TECHNICAL NOTE

LAND AT BURDELL ROAD, YAPTON, WEST SUSSEX RESIDENTIAL DEVELOPMENT

Client: Driftstone Homes Ltd
Reference: 6145

1.1.1 This Technical Note (TN) has been prepared by Bright Plan on behalf of Driftstone Homes Ltd address highway consultation comments raised by West Sussex County Council (WSCC) regarding the planning application F/5/21/PL for residential development on land at Burdell Road, Yapton, West Sussex.

Drawing Status	FINAL		
Client	Driftstone Homes		
Project	Burndell Road, Yapton		
Drawing Title	Pedestrian Visibility Splays		
Scale	1:250	Date	July 21
Drawn By	SMO	Checked By	ALB
Drawing No.	2020-6145-005		Rev. C

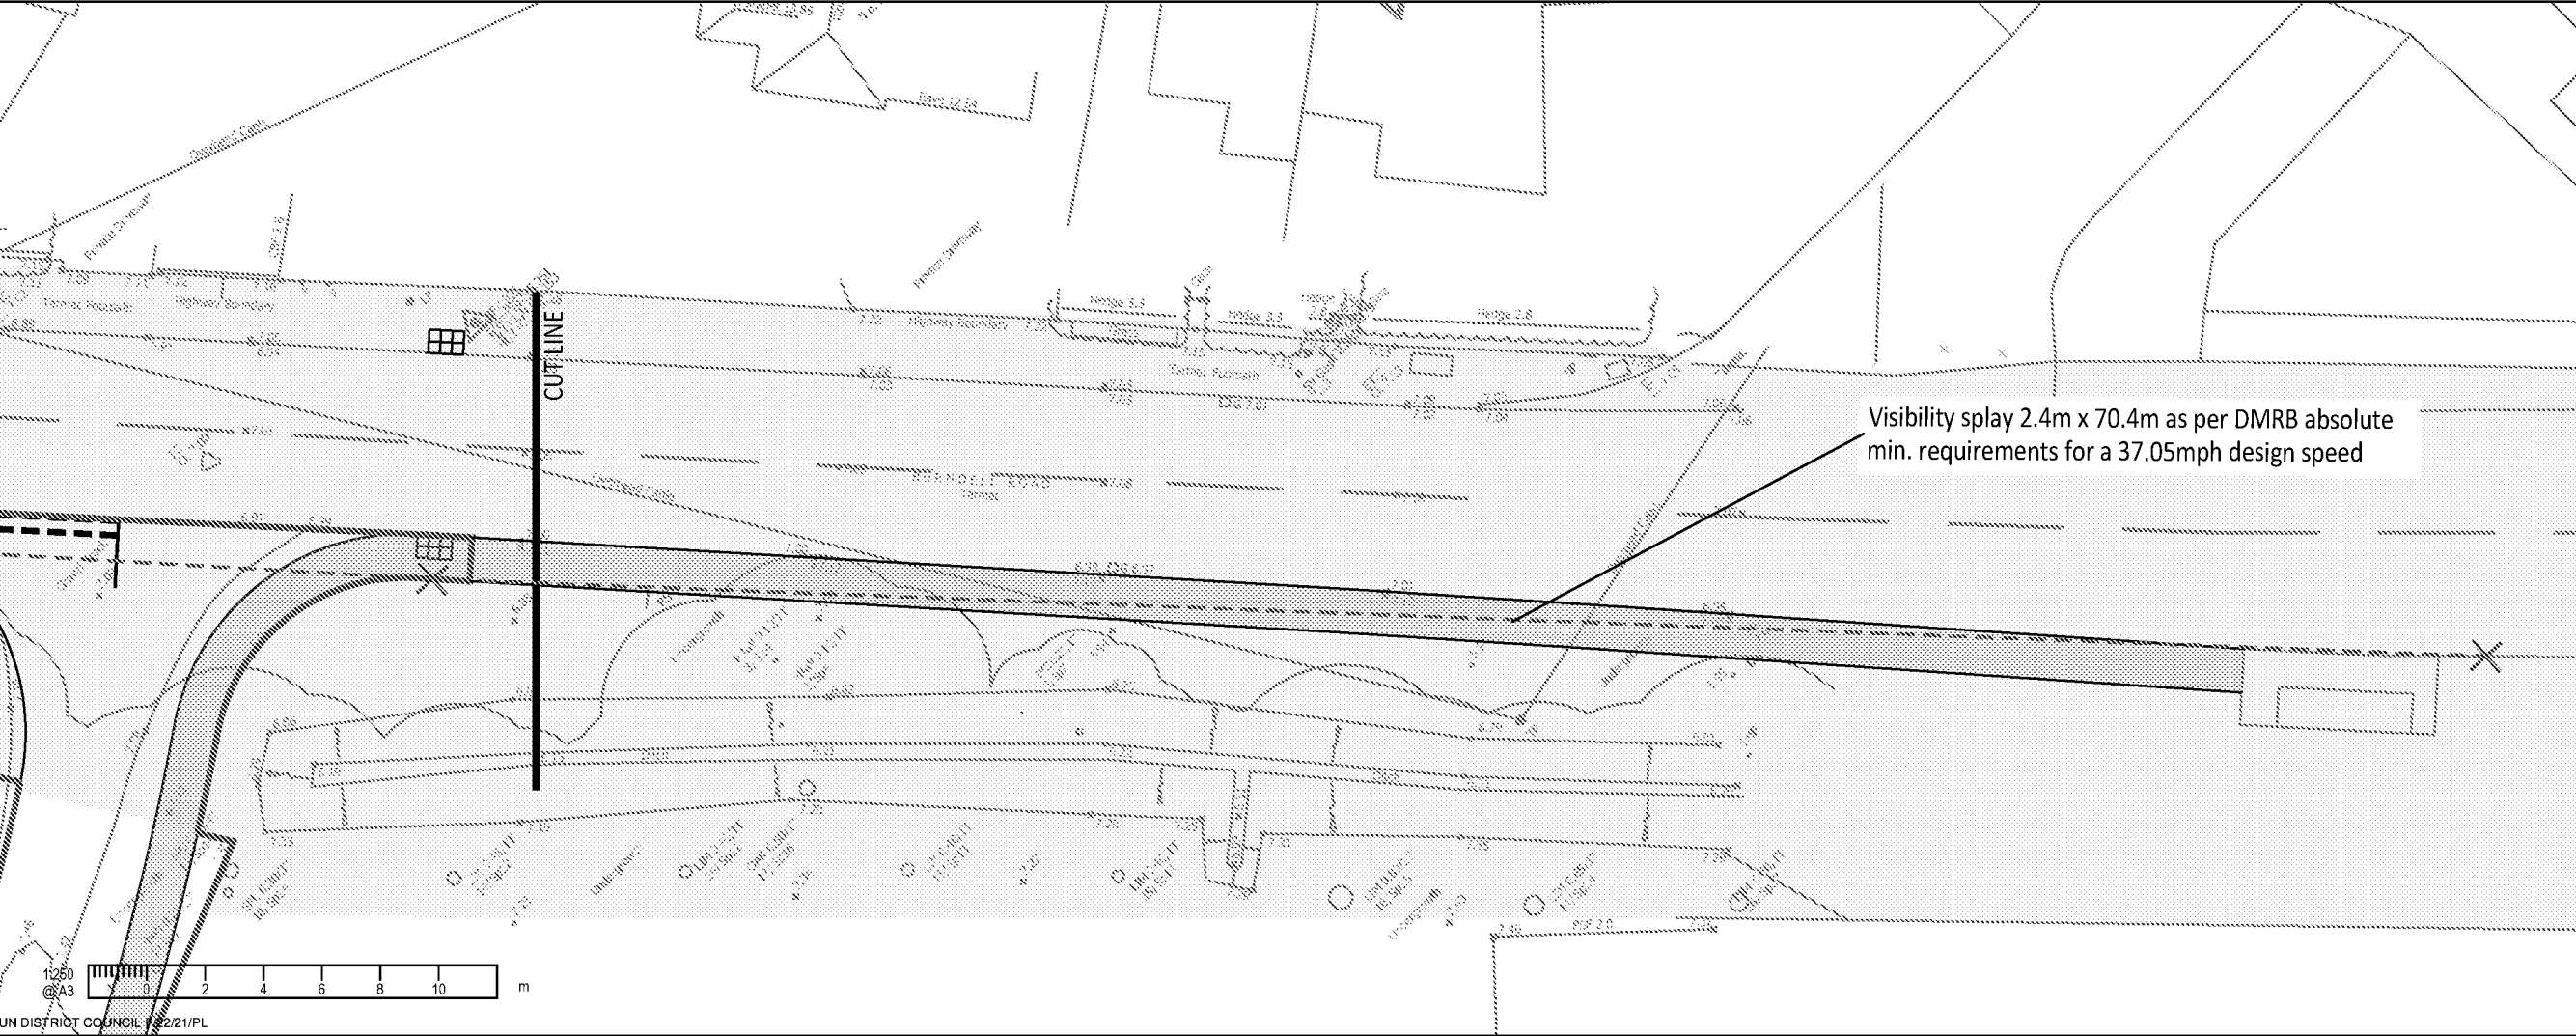
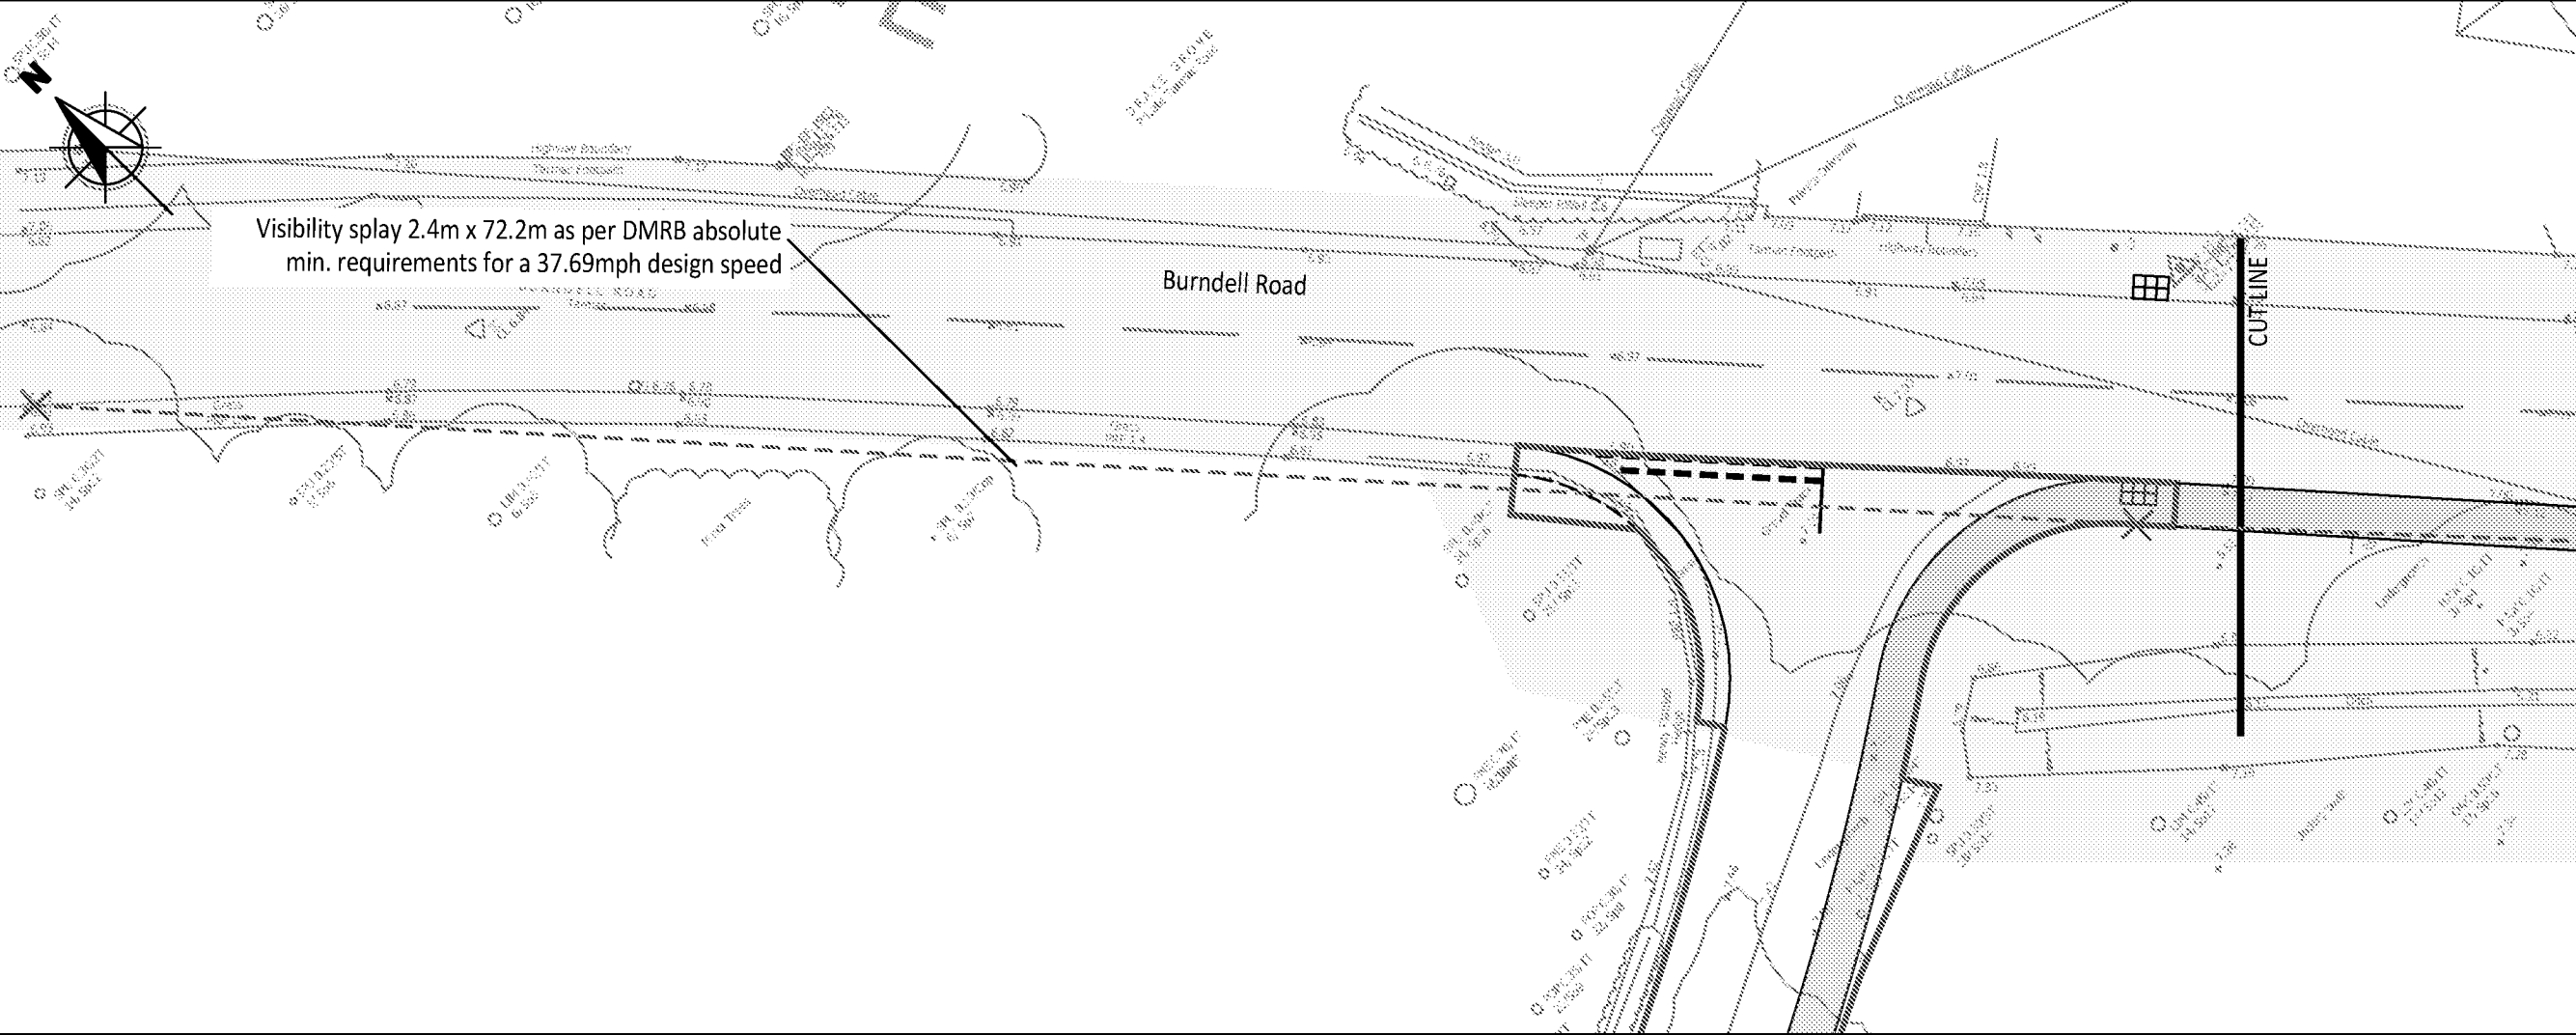
Location: B – Burndell Road south-east of the access junction (Dwg. 2020-6145-005 Rev. B)

Summary: Risk of pedestrian trips, falls and collisions with passing traffic.

The pedestrian visibility splays drawing shows that, 60m away from the proposed uncontrolled pedestrian crossing point on Burndell Road, there is a bus stop and shelter for north-westbound buses (photo 3).

Residents of, or visitors to, the new development, wishing to use the north-westbound bus route, will have to cross Burndell Road twice to do so, once using the new uncontrolled crossing at the new access junction, and again at the existing bus stop, where there are no dropped kerbs or tactile paving (photo 4).

It is more likely, however, that pedestrians will walk along the verge between the bus stop and the new development, risking trips and falls on the verge, or will walk in the carriageway when the verge is muddy, risking collisions with passing traffic.

- 2.2.4 Pedestrian visibility from crossings have also been demonstrated in accordance with the recorded 85th percentile design speeds with sight lines calculated using DMRB absolute minimum coefficients in **Drawing 2020-6145-005**.

The footway on the south-east shoulder of the development should be extended 60m to the existing north-westbound bus stop. This will also help safeguard the visibility splay south-eastwards from the development access junction (see problem 2.1 above).

Problem no.	Problem Accepted (yes/no)	Recommended Measure Accepted (yes/no)	Design Organisation Response	Over Seeing Organisation Response	Agreed RSA Action
2.1	Yes	Yes	All vegetation will be removed from within the visibility envelope. Vegetation to be replaced with grass to the north west and a 1.5m wide footway to the south east.		
2.2	Yes	Yes	The footway has been extended c.60m to the southeast to provide access to the existing bus stop.

Problems Location Plan

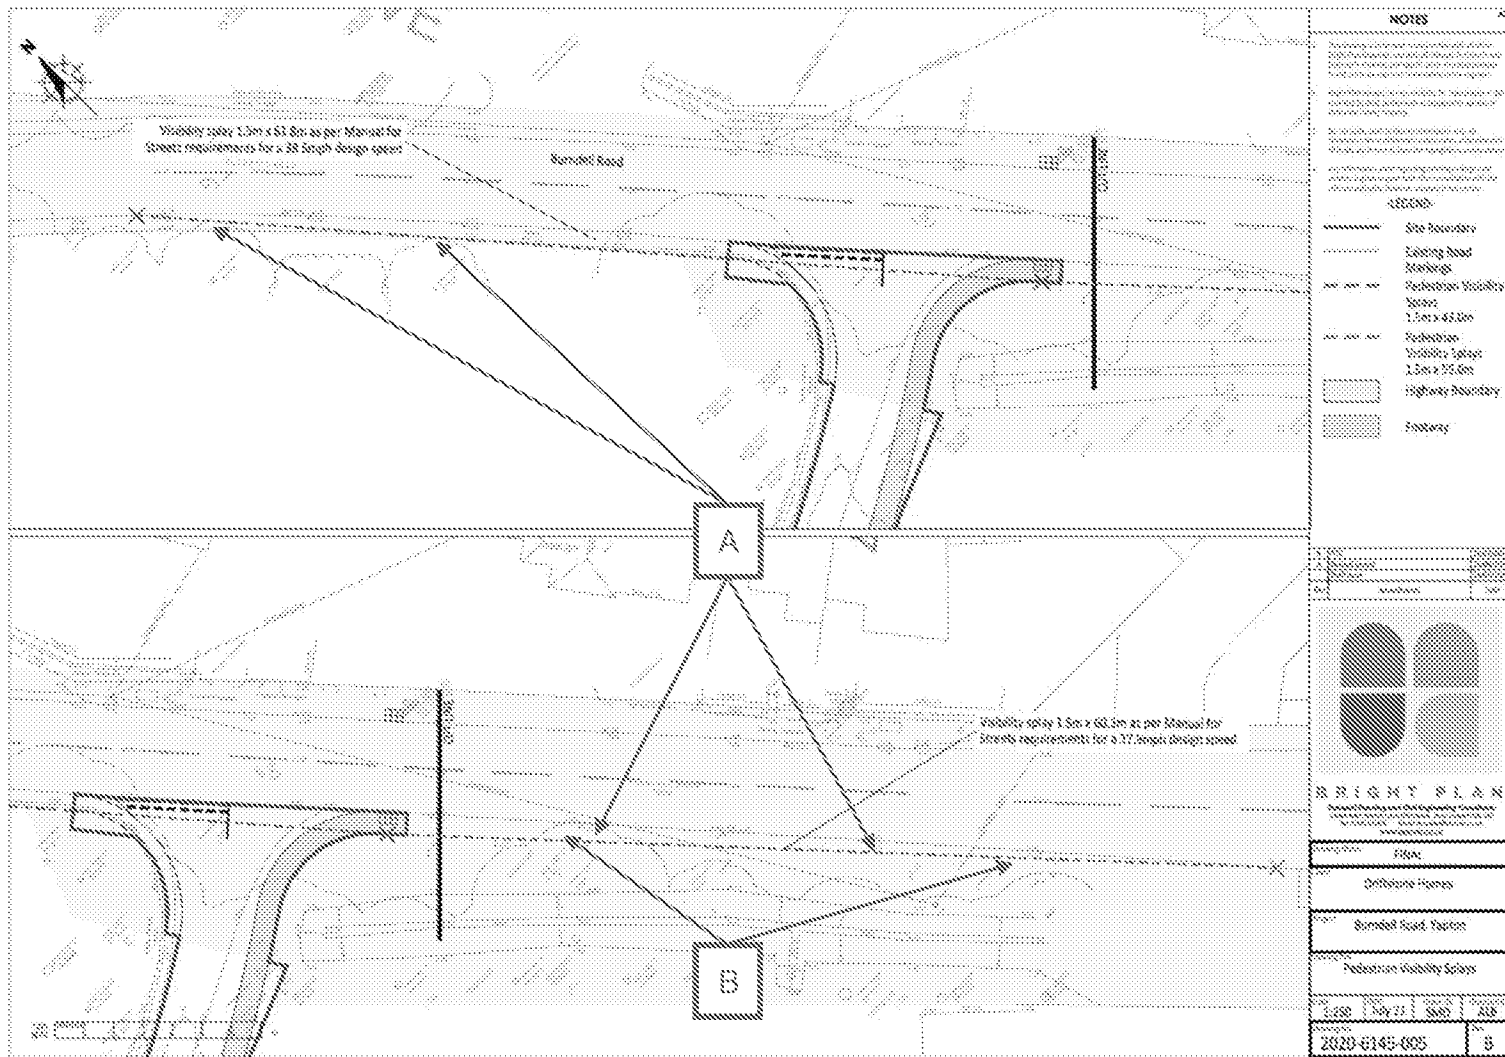
1.5 All the problems described in this report are considered by the audit team to require action to improve the safety of the scheme and minimise accident occurrence. A plan showing the locations of the problems is shown in **Appendix B**.
